Report of Dam Safety Assessment of Coal
Combustion Surface Impoundments
Dayton Power and Light Company
O.H. Hutchings Electric Generating Station
Miamisburg, OH

AMEC Project No. 3-2106-0177.0006

April 2011

**SECTION A-A EAST AND WEST PRIMARY SETTLING POND
TYPICAL COMMON DIKE CROSS SECTION**

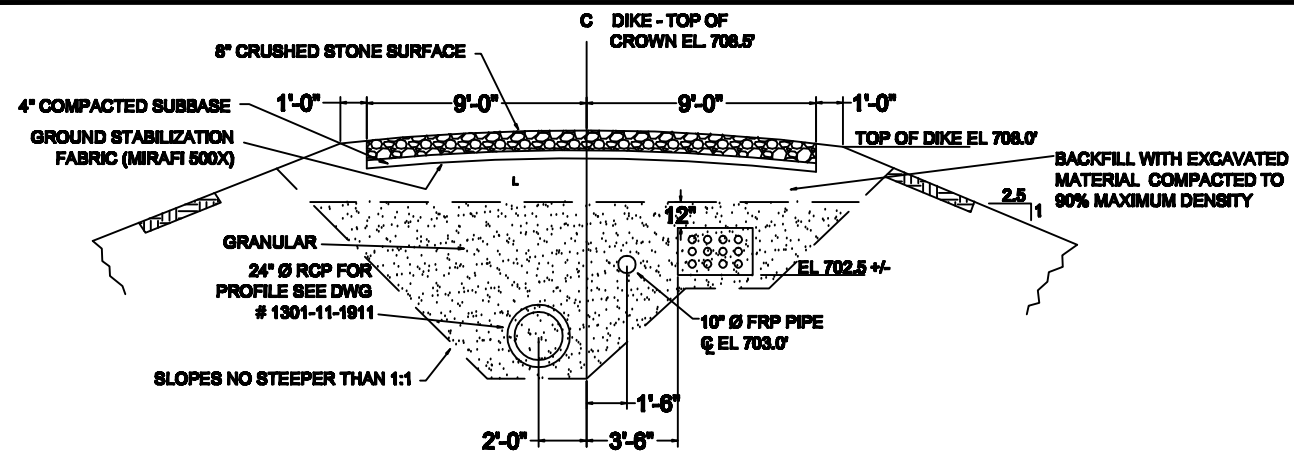
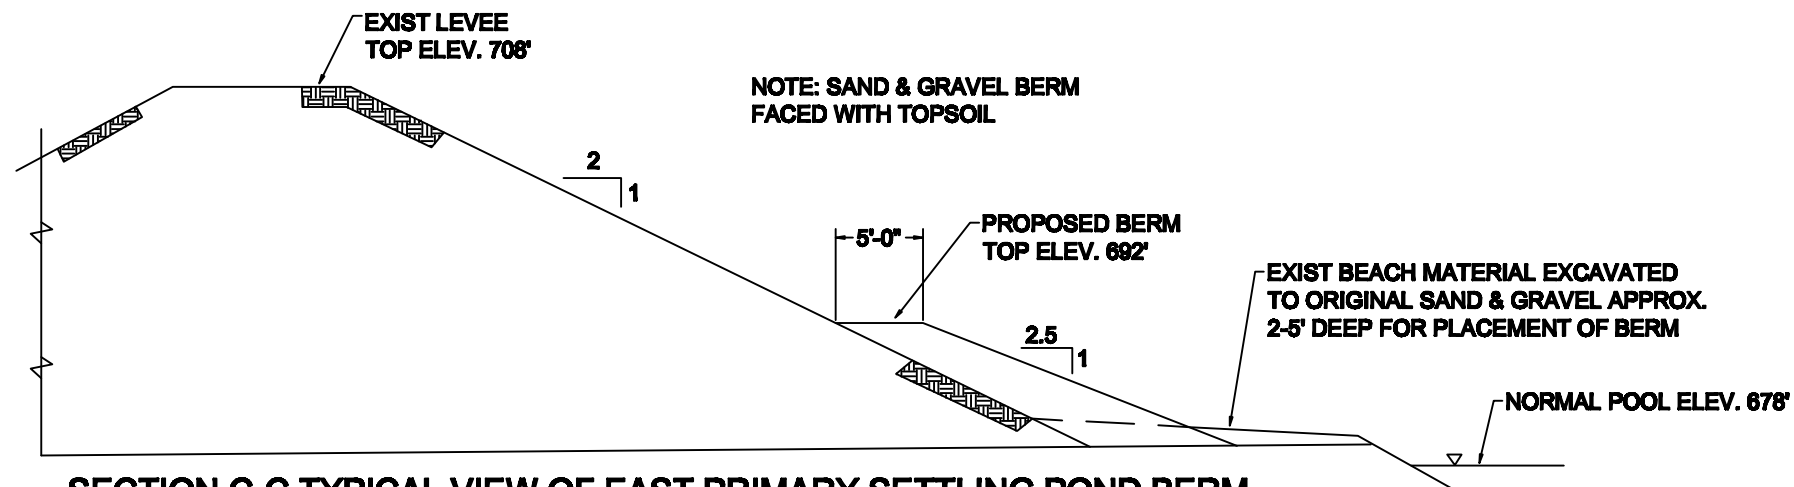
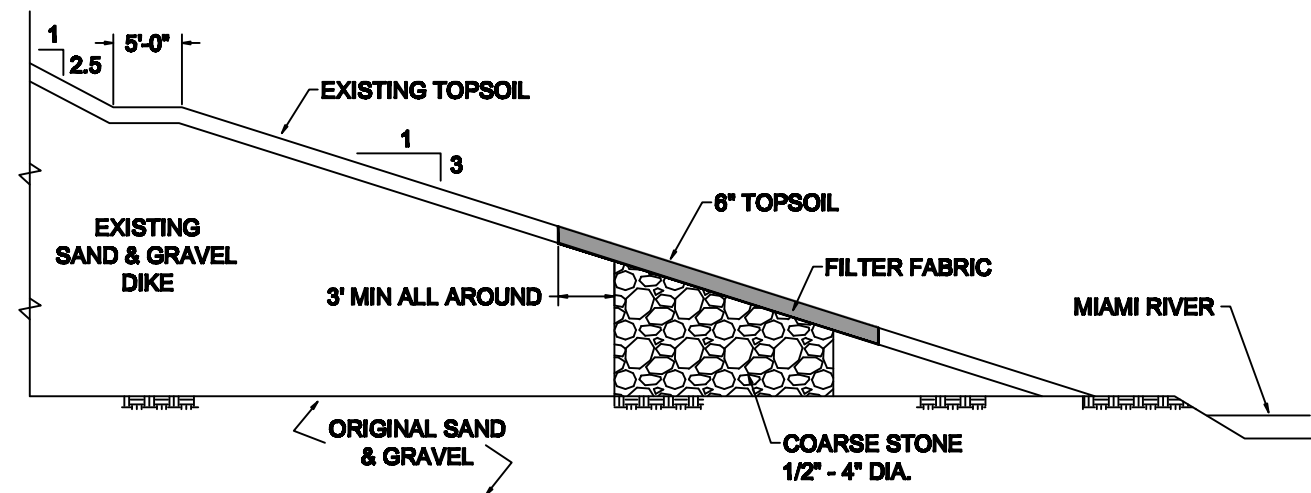
Review of a provided design drawing (1301-11-1902) by AMEC indicate a 2.5H:1V slope along the interior dikes of the common embankment between the East Primary Settling Basin and West Primary Settling Basin. Section C-C of this drawing illustrates an area along the northern section of the east downstream dike of the East Settling Pond with a downstream slope of 2H:1V. A toe berm with a slope of 2.5H:1V constructed 16 feet from the dam crest had been proposed along this cross section. Section D-D labeled "Typical repair method of the dike", is located along the southern portion of the eastern downstream dike of the East Settling Pond and illustrates a repair of the sloughed area. This included a five-foot bench above the repair area, excavating soil from the sloughed area, and filling with coarse stone. Filter fabric was to be placed around the surrounding soil. Downstream slopes of 1H:2.5V are noted along the upper portion of the cross section and slopes for the repair section were reported as 1H:3V. We note that provided drawings did not illustrate a typical cross section around the north or south dike of the East Primary Settling Pond. A plan view and cross sections of the East Primary Settling Pond are included as Figures 5 and 7.

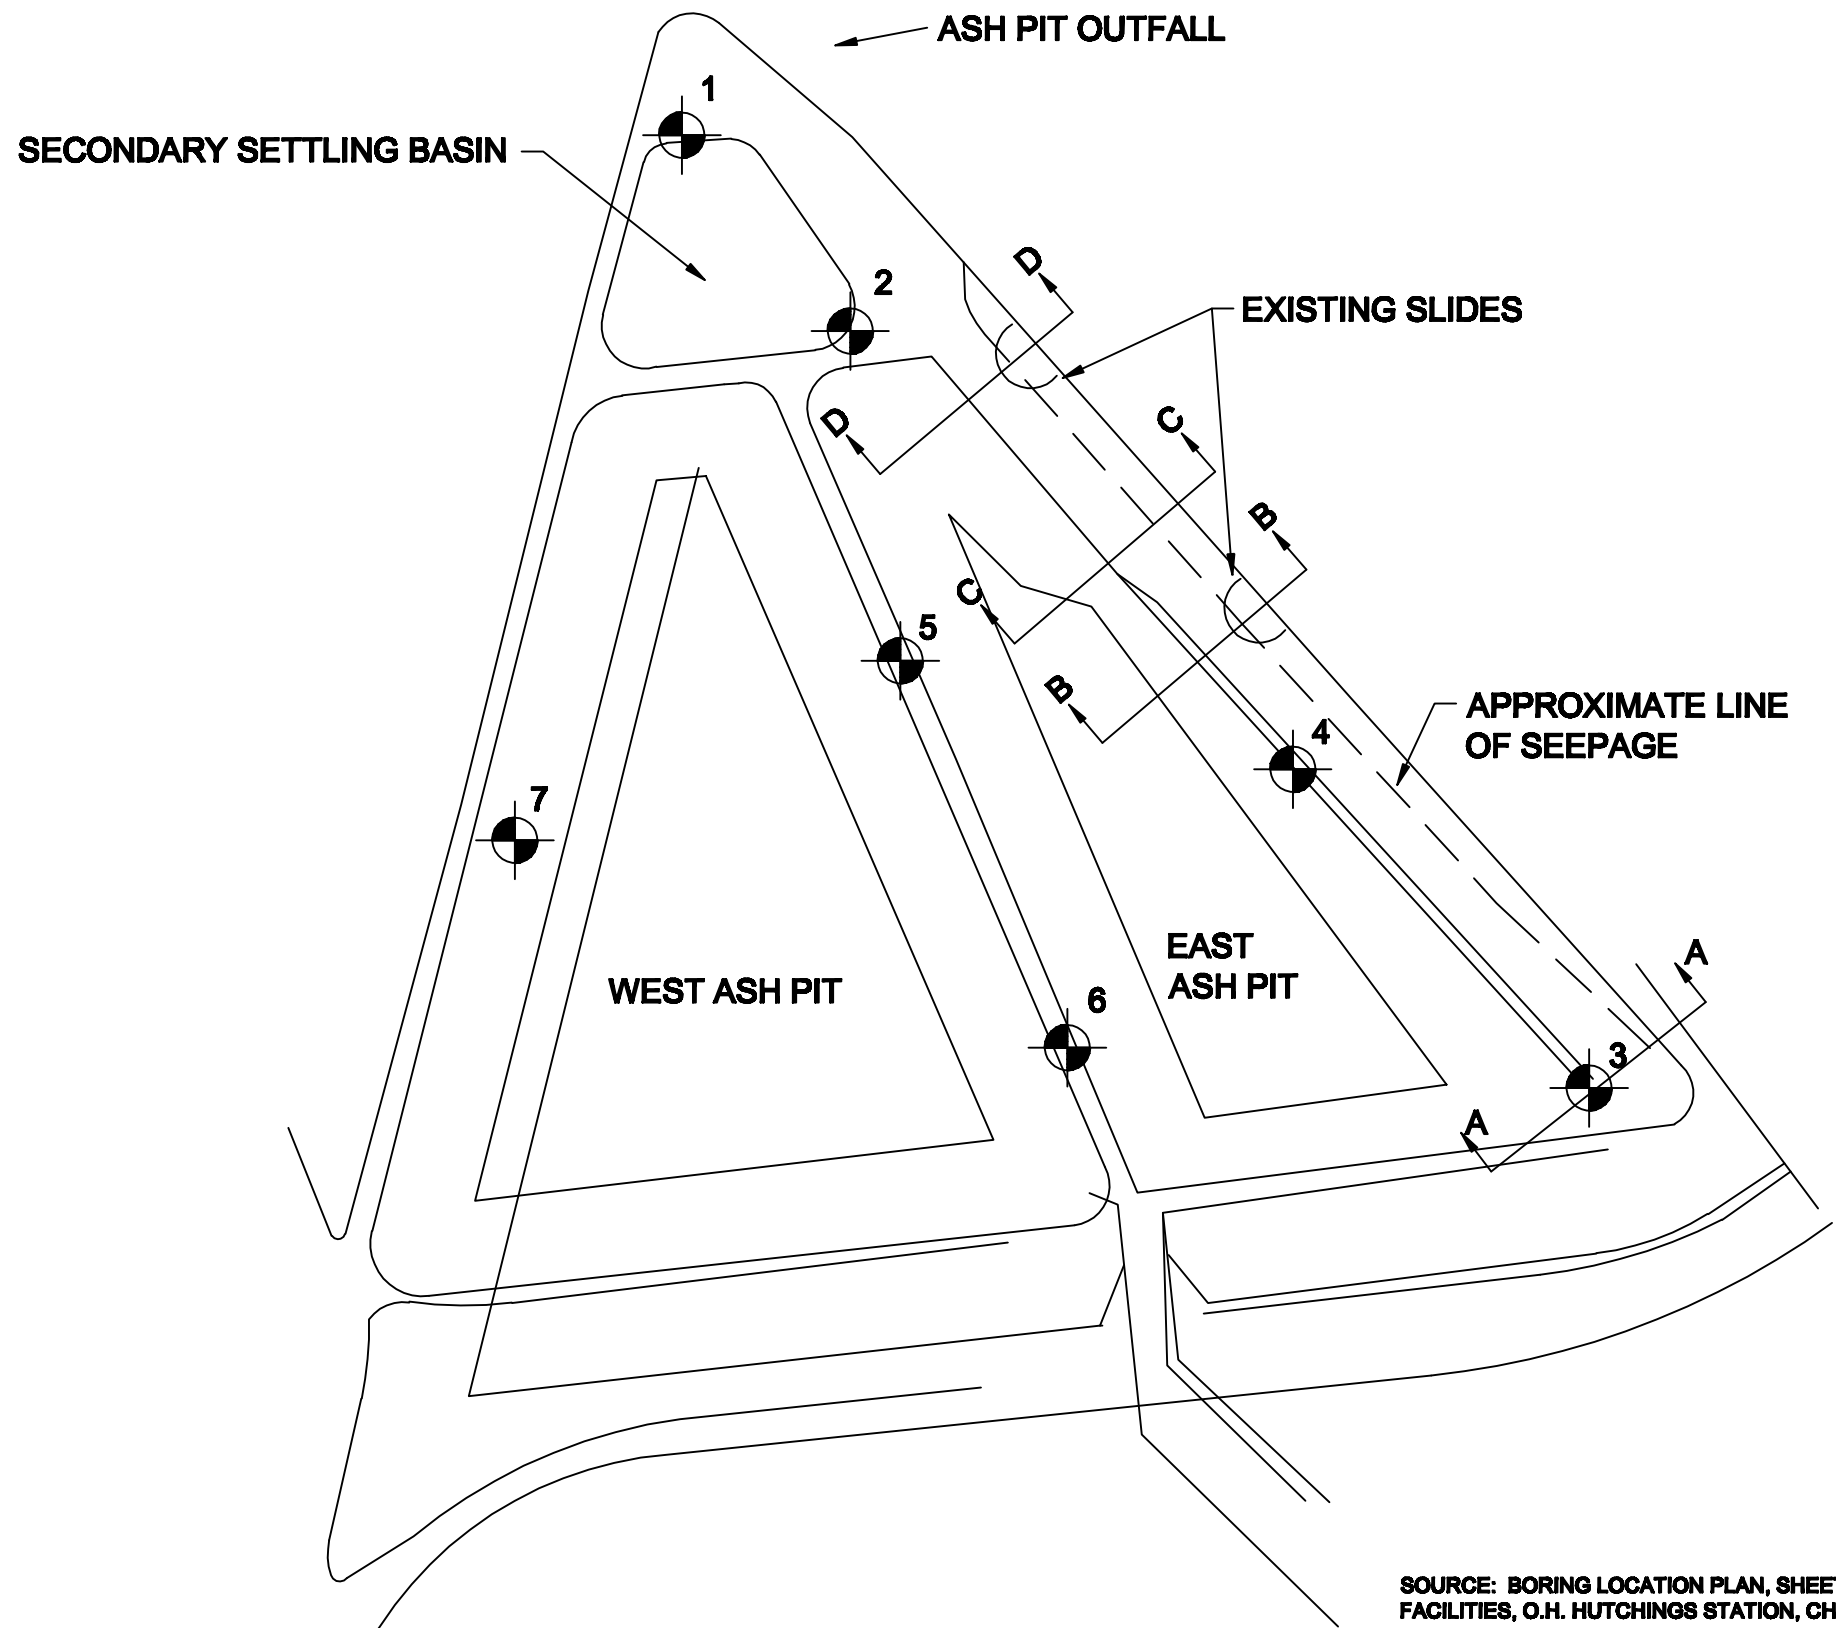
determine the seepage conditions and location and extent of the existing slides. Cross sections of the dike were taken at four different locations. Figure 8 illustrates the location of the slides, and extent of the seepage.

Circle Number	Location of Slide Plane	Factor of Safety	
		Static	Earthquake
1	Mini Slide on Saturated Portion of Slope	0.94	0.80
2	Interface between Embankment Material and Ash	1.27	1.10
3	Interface between Ash and Black Organic Silt	1.34	1.17
4	Interface between Black Organic Silt and Original Sand and Gravel	1.09	0.94
